**“PROJECT NO. 2241
EAST LELAND ROAD PAVEMENT MAINTENANCE**

ADDENDUM NO. 1

Issued: 7/27/23

Specification Sheet – GlasPave® 25/50 Waterproofing Paving Mat

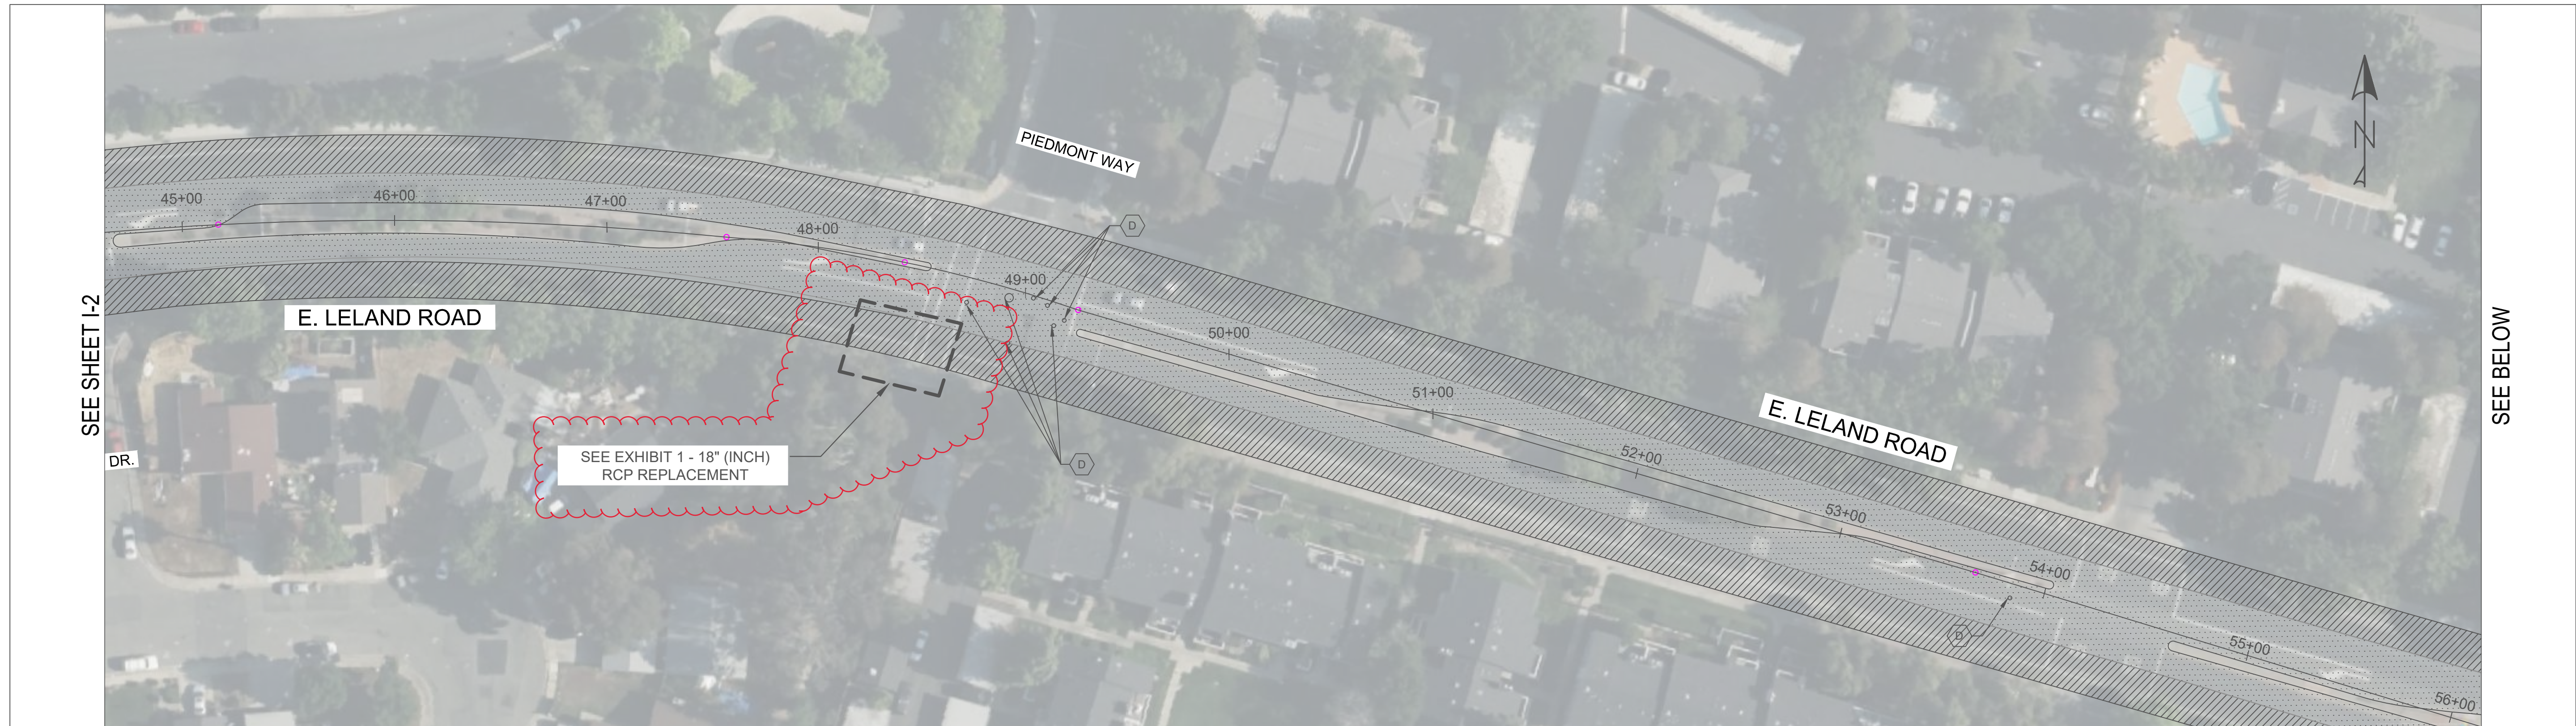
- Bid Item 7 ‘Base Repair (Revokable)’ on Section 01 22 00 – 4, no. 3, of the ‘Unit Prices’ specifications. The following has been revised as stated: “Base Repair shall be to the depth of two (2) inches after the two (2) inch

mill has been performed. Pavement fabric/mat shall be Tensar Glaspave 50 (GP-50) as shown in the attached cut sheet. Pavement fabric/mat shall be placed between the existing asphalt surface and new HMA. HMA shall be placed in lifts not to exceed three (3) inches.” See attached updated Specification Section 01 22 00 ‘Unit Prices.’

**PROJECT 2241
 E LELAND ROAD PAVEMENT MAINTENANCE
 IMPROVEMENT PLANS**

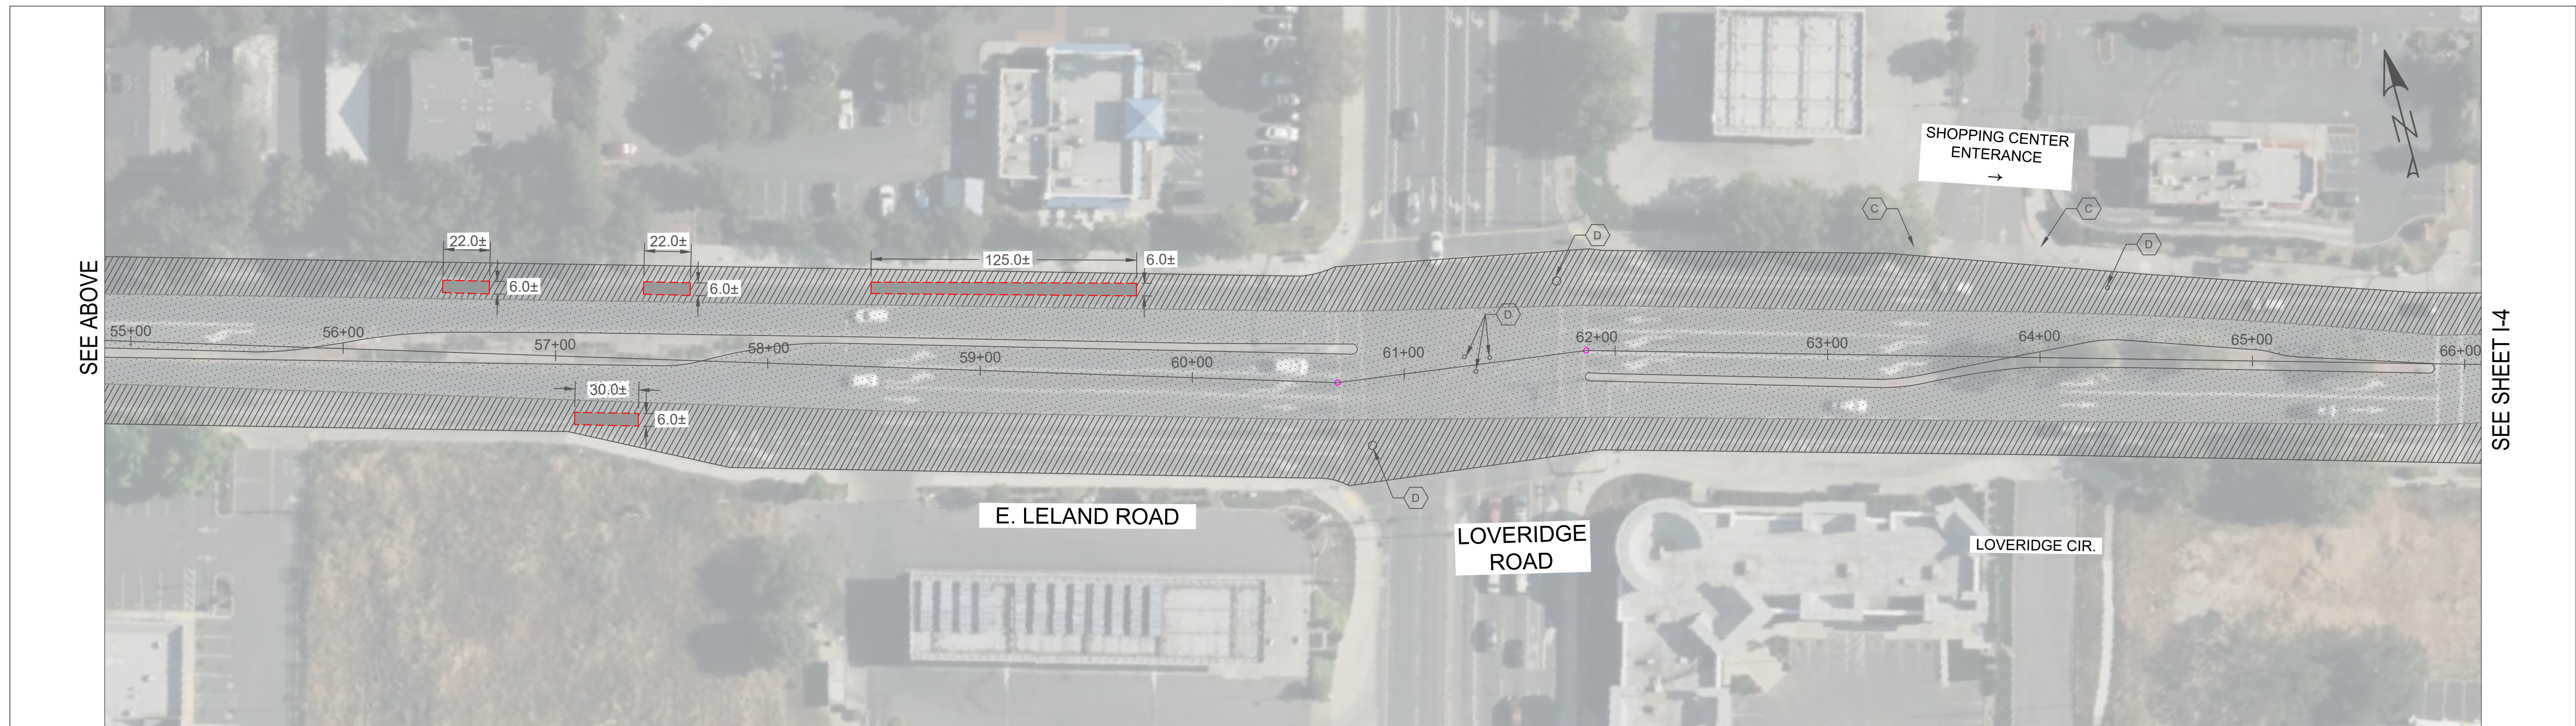
ITEM 5 – DRAWING REVISION: SHEETS I-3, EXH-1, EXH-2

- See attached revised sheet I-3 and Exhibit 1 - “18” (inch) RCP Replacement”.

PROJECT 2241
EXHIBIT 1 - 18" RCP REPLACEMENT

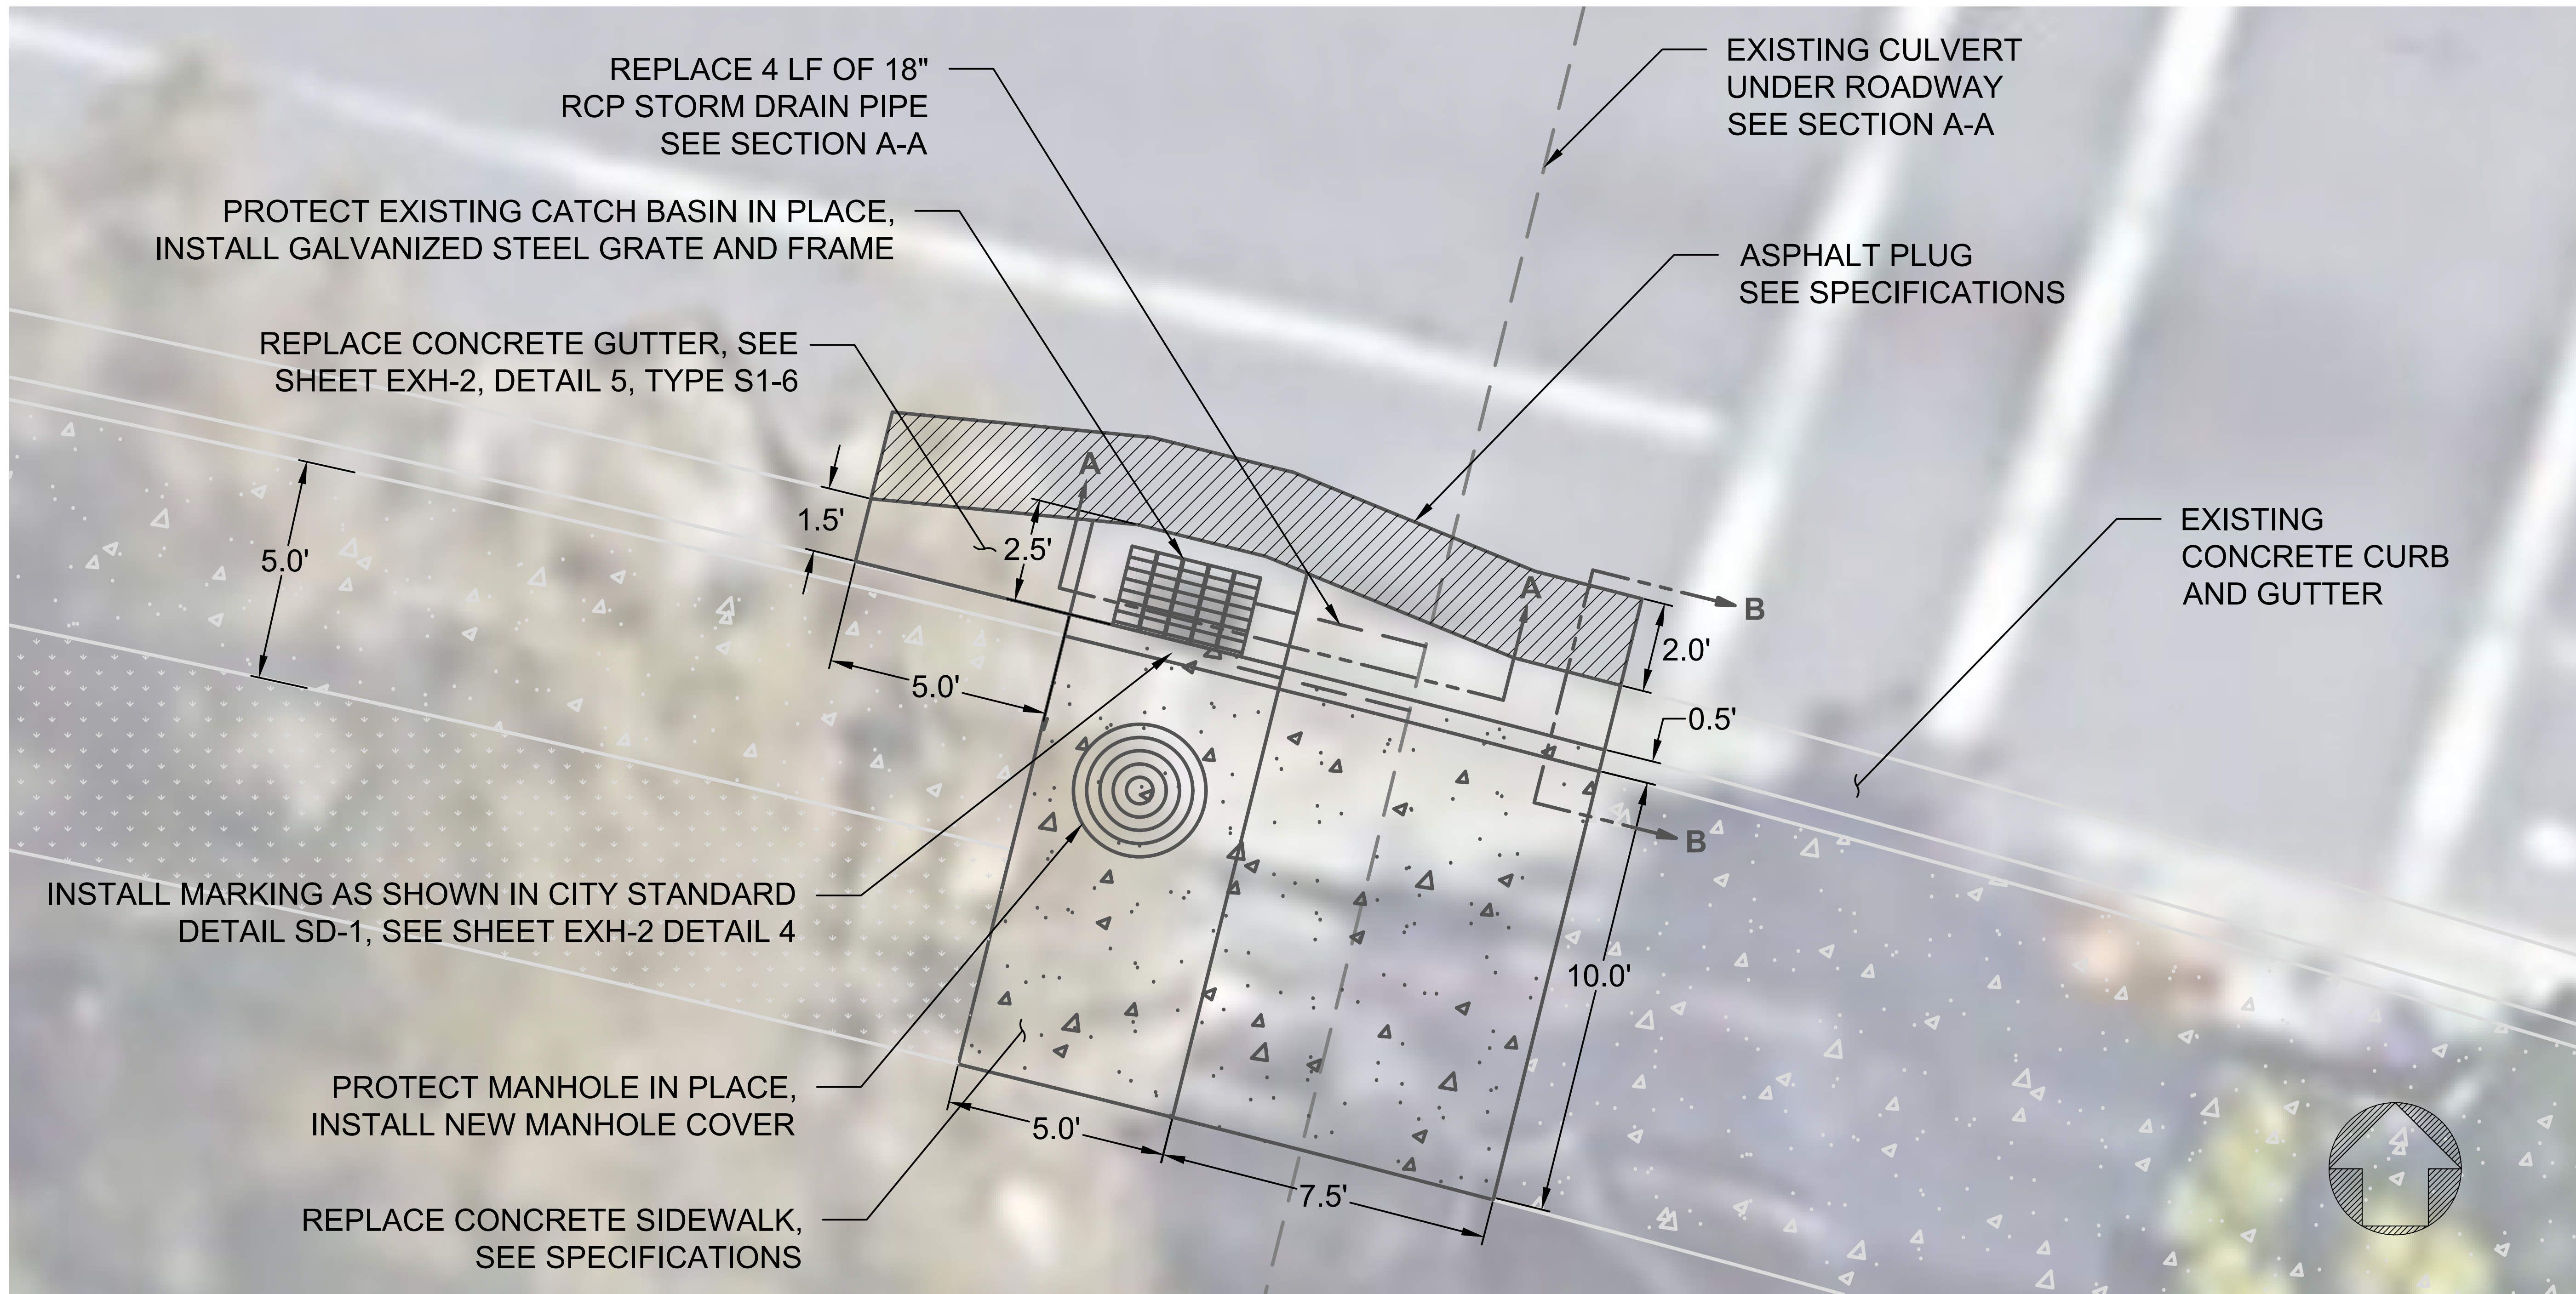
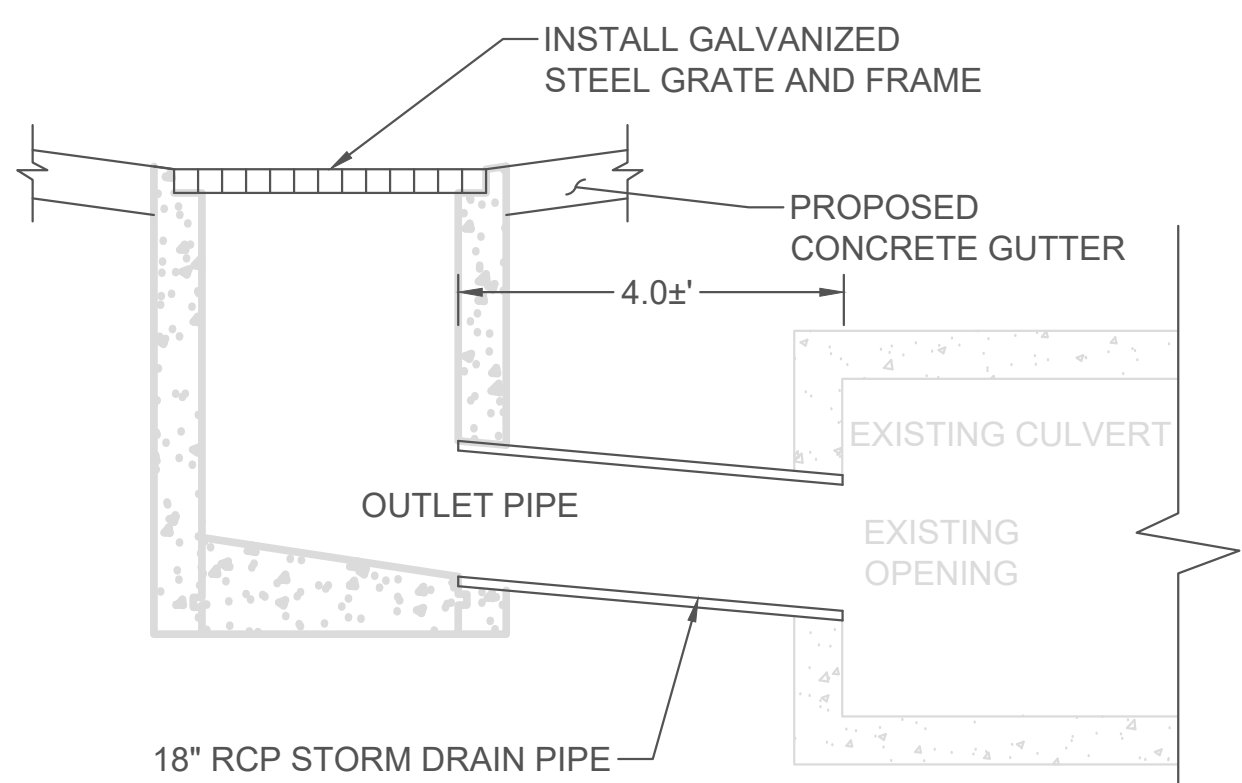
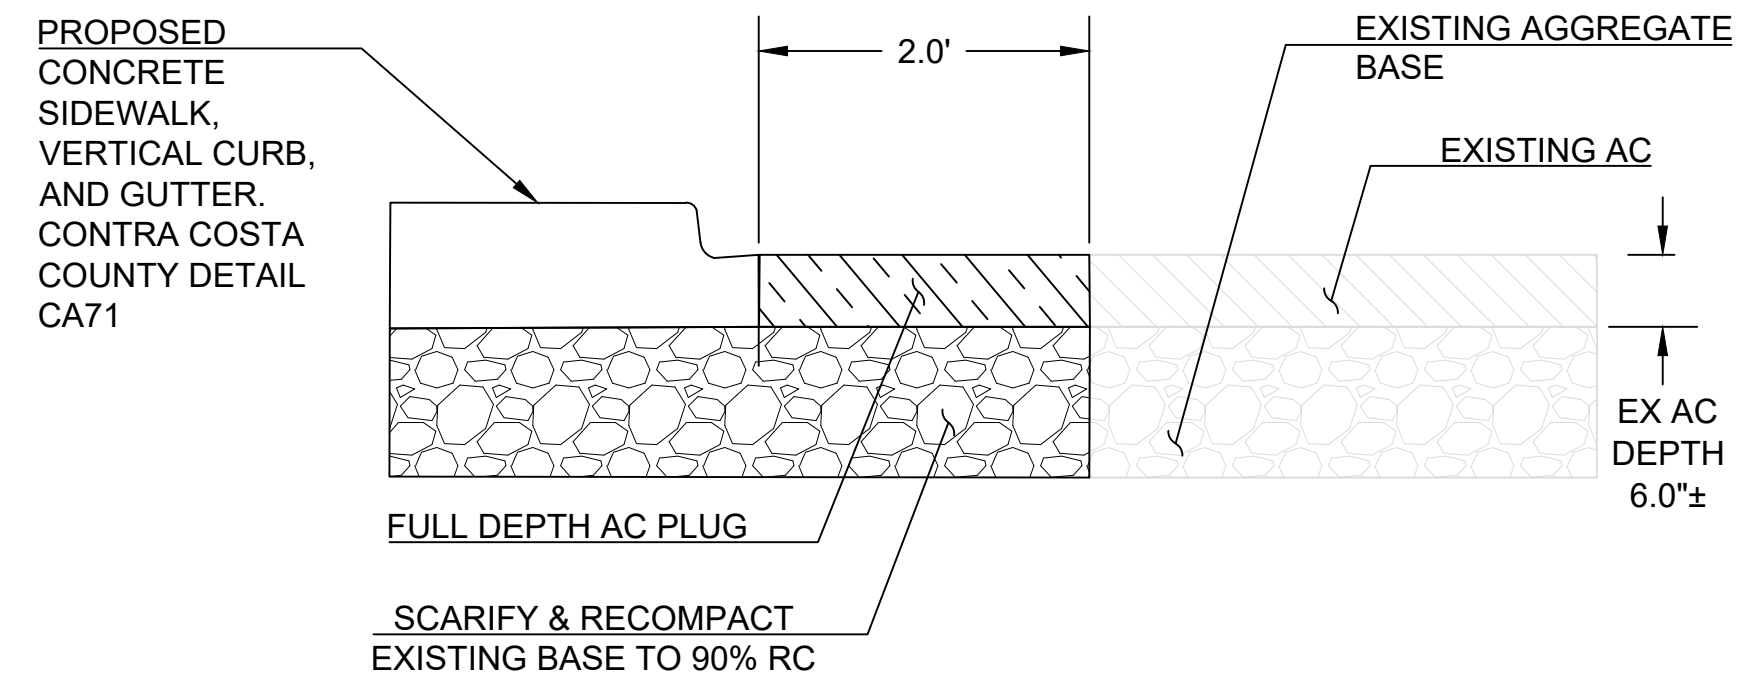
- Bid Item 24 “18” (inch) RCP Replacement”. See attached updated Bid Schedule, Section 01 22 00 Unit Prices, and Exhibit 1 - 18” (inch) RCP Replacement, replacement of the existing catch basin, steel frame and grate, and removal and replacement of the existing storm drain manhole cover”.
- Bid Item 25 “Concrete Curb and Gutter”.
See attached updated Bid Schedule and Section 01 22 00 Unit Prices.
- Bid Item 26 “Concrete Sidewalk Replacement”.
See attached updated Bid Schedule and Section 01 22 00 Unit Prices.
- Bid Item 27 “Asphalt Plug”.
See attached updated Bid Schedule and Section 01 22 00 Unit Prices.

REPLACE 4 LF OF 18" RCP STORM DRAIN PIPE SEE SECTION A-A

EXISTING CULVERT UNDER ROADWAY SEE SECTION A-A

PROTECT EXISTING CATCH BASIN IN PLACE, INSTALL GALVANIZED STEEL GRATE AND FRAME

PROTECT MANHOLE IN PLACE, INSTALL NEW MANHOLE COVER
